**STAFF REPORT & FINDINGS OF FACT  
FLORENCE COMMUNITY DEVELOPMENT DEPARTMENT  
Planning Commission  
Exhibit "A"**

**Public Hearing Date:** December 13, 2016                      **Planner:** Wendy FarleyCampbell  
**Date of Report:** December 6, 2016  
**Application:** PC 16 26 CUP 08

**Proposal:** A request for Conditional Use Permit and Design Review for a new 128' cell tower east of Highway 101, west of Spruce St. and north of Munsel Lake Road.

SHEET NUMBER: **A-2** REV.: **2**

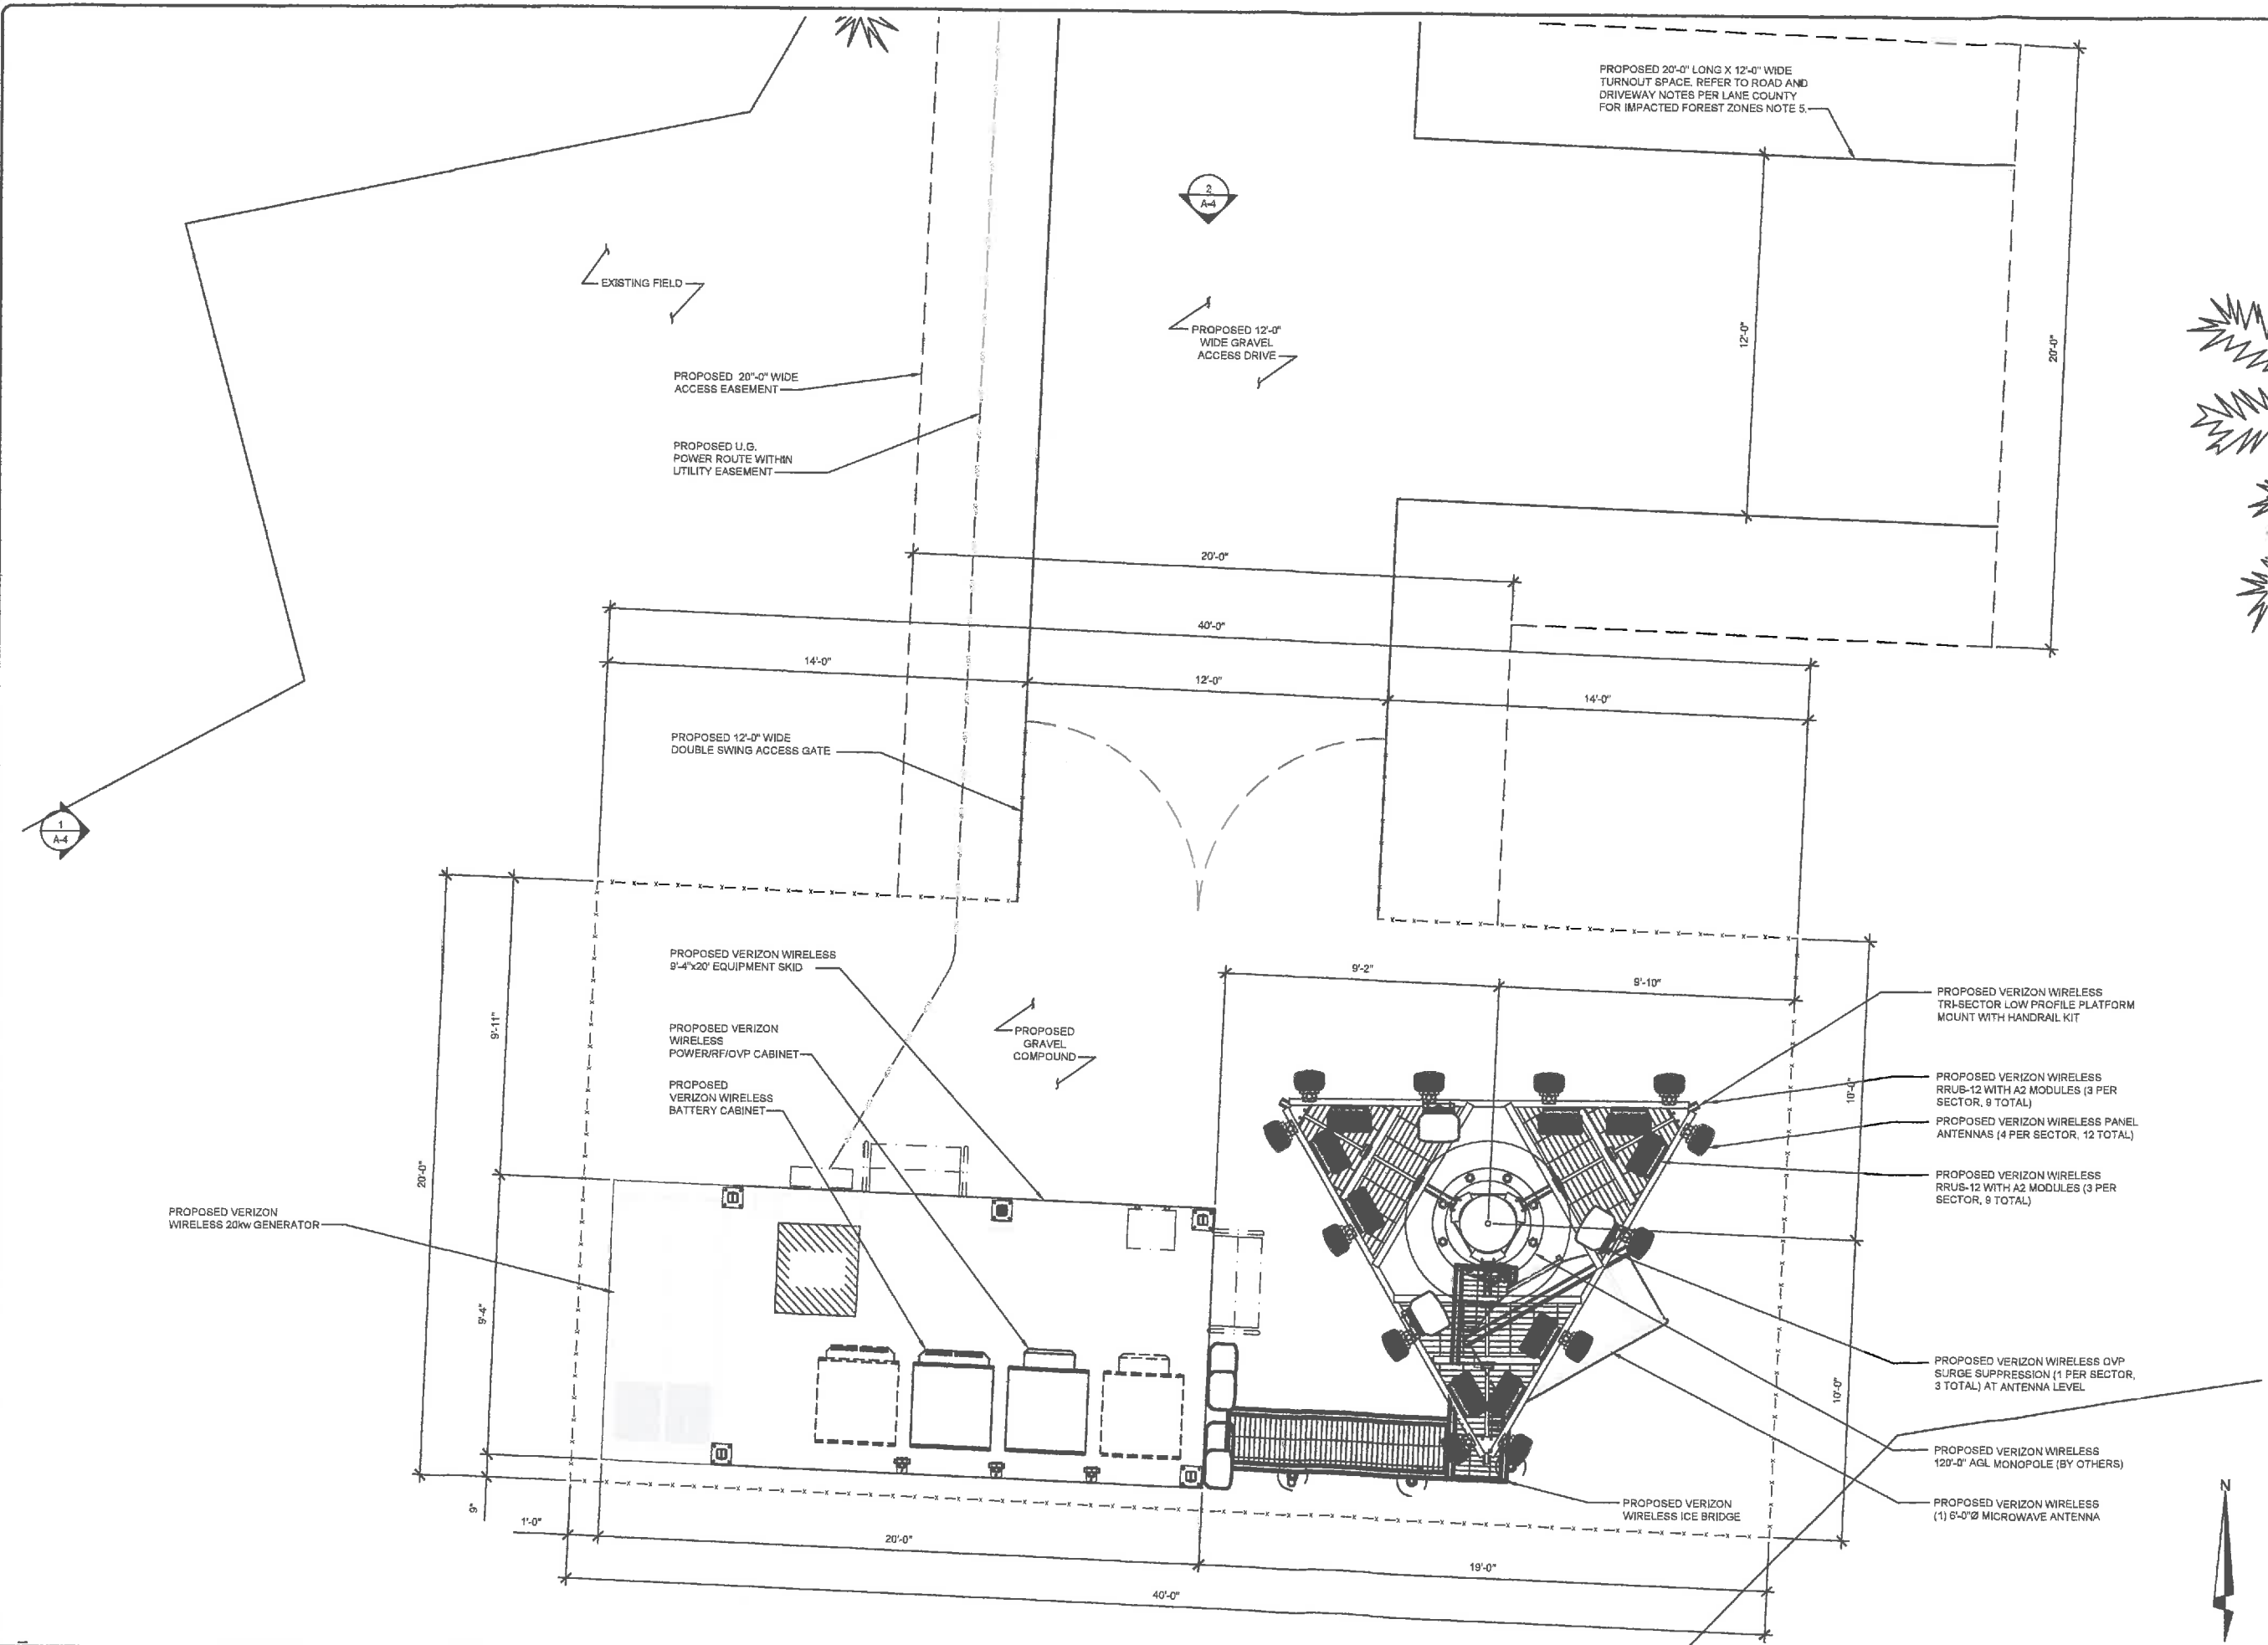
The applicant has proposed an area for parking to occur but had not delineated it on the site plan specifically. This area is adjacent to the gate at the end of the driveway south of the turnaround. This criterion is met.

The site plan does indicate the intent to pave either the parking, driveway or entrance apron. The code requires all parking and loading areas and the first 50' of a driveway apron from a street be paved. The site plan shall be modified to include paving the first 50' of the driveway apron from the highway. The designated parking area shall also be paved. The turnaround area and other travel lanes may be gravel. **(Condition 3.1)**

The applicant has submitted an access/parking plan with dimensions identified. It does not contain the specific details required above. The applicant shall provide a revised parking plan with the building permit that illustrates the parking stall design and dimensional requirements of FCC 10-3-9. **(Condition 3.4)**

SHEET TITLE:  
**WEST & NORTH ELEVATION**

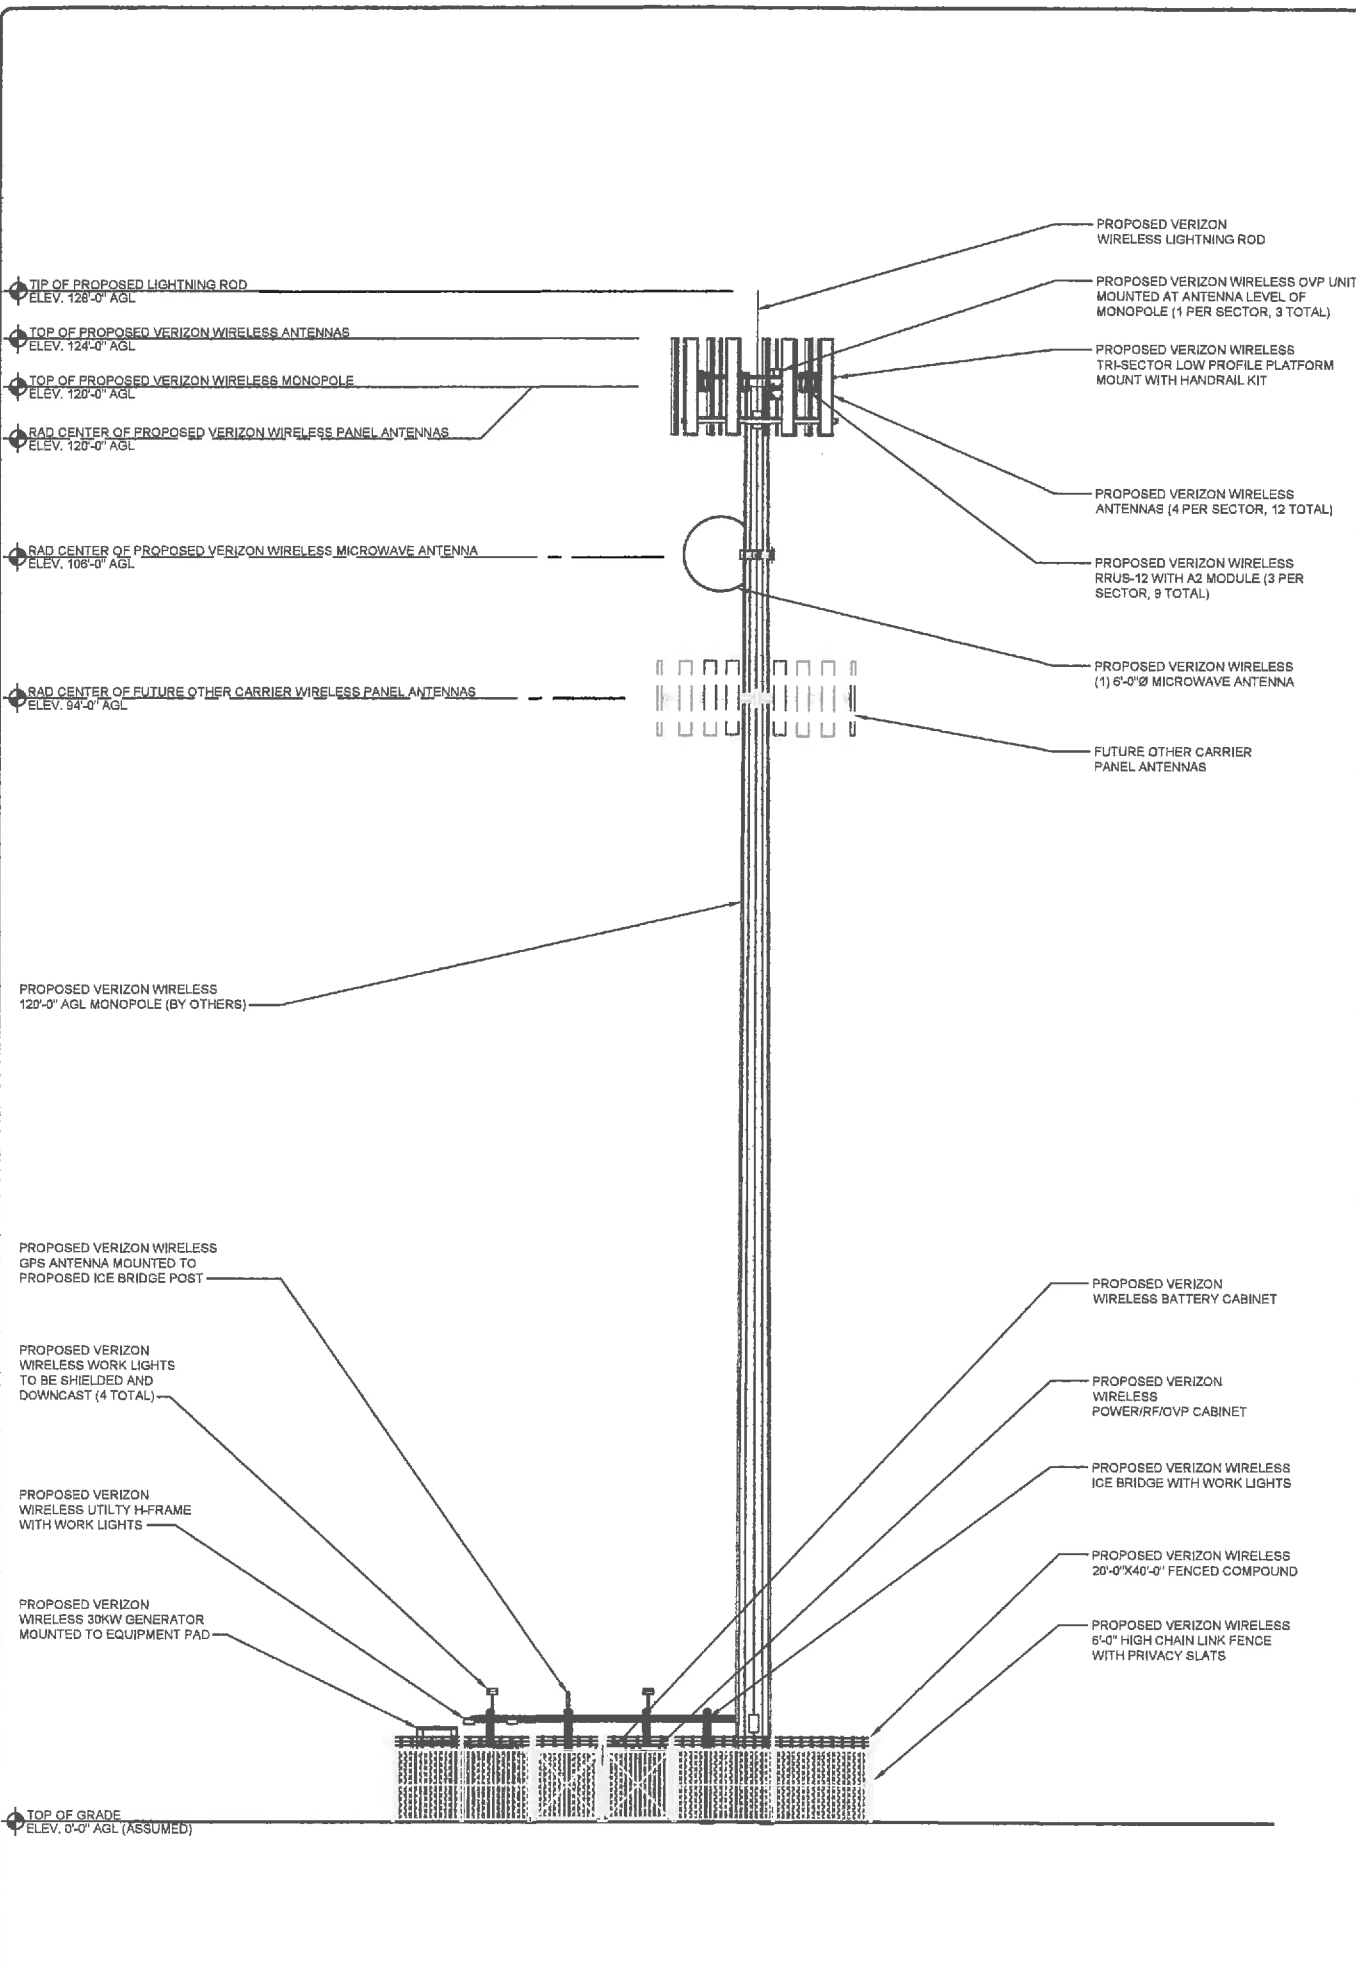
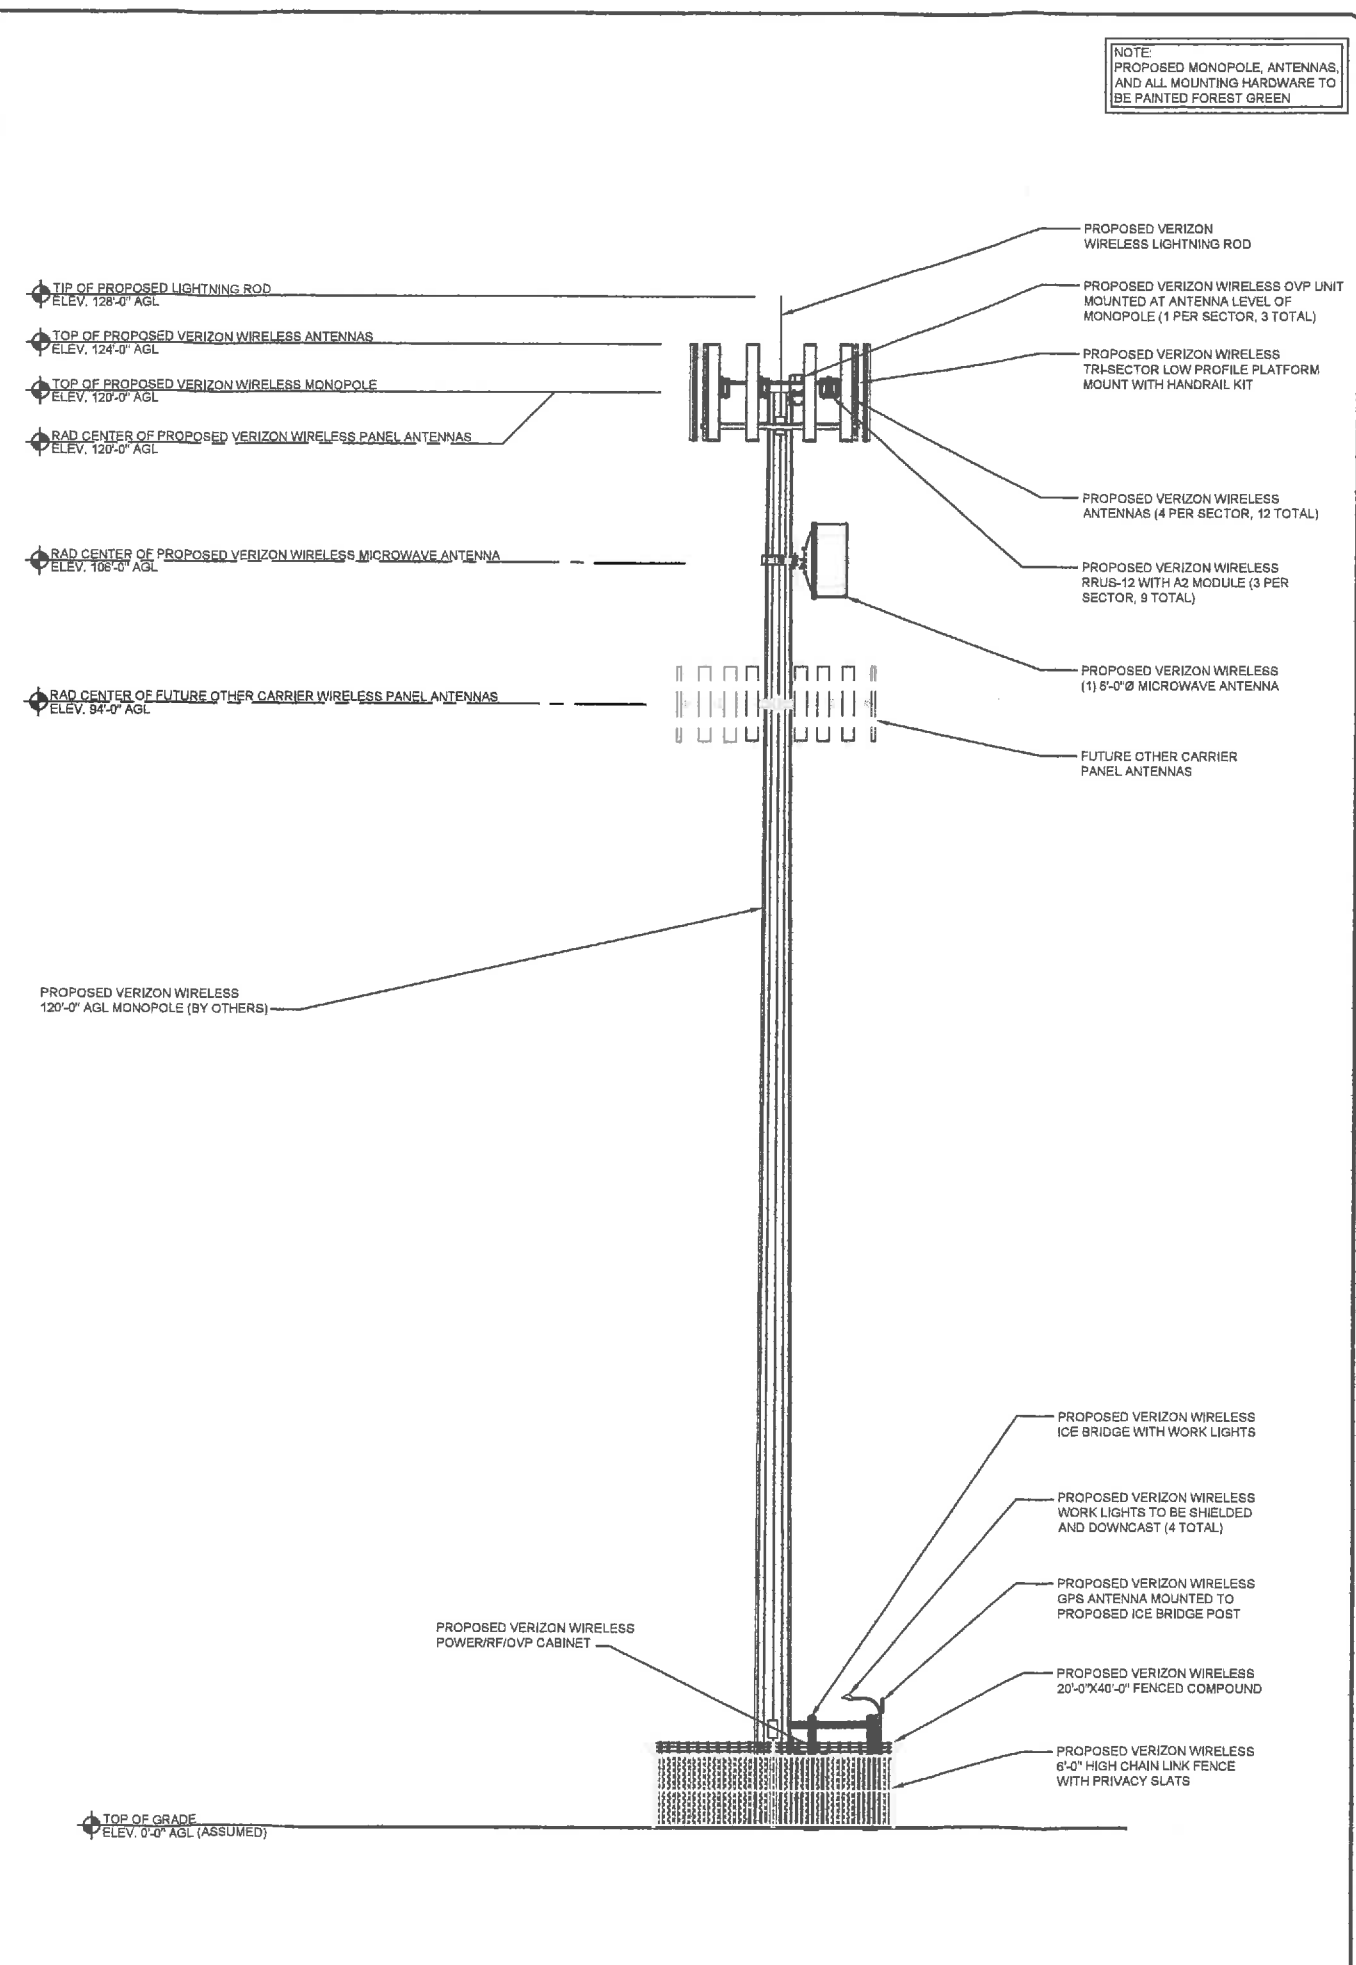
The applicant submitted a partial number and location of luminaires on the elevation plan. Four work lights are proposed for the ice bridge. And, it appears that two lights are proposed for the H-Frame. Neither luminaire spec sheets or photometric reports were provided for review. The applicant shall submit additional lighting information meeting FCC 10-37-4 to be evaluated and approved by the Planning Department prior to issuance of Certificate of Occupancy. **(Condition 7.1)** The applicant shall ensure that lighting fixtures do not project light onto adjacent or nearby property. **(Condition 7.2)** The applicant shall add lighting fixtures or reposition proposed fixtures to provide at least two foot-candles of illumination for the parking space. **(Condition 7.3)**
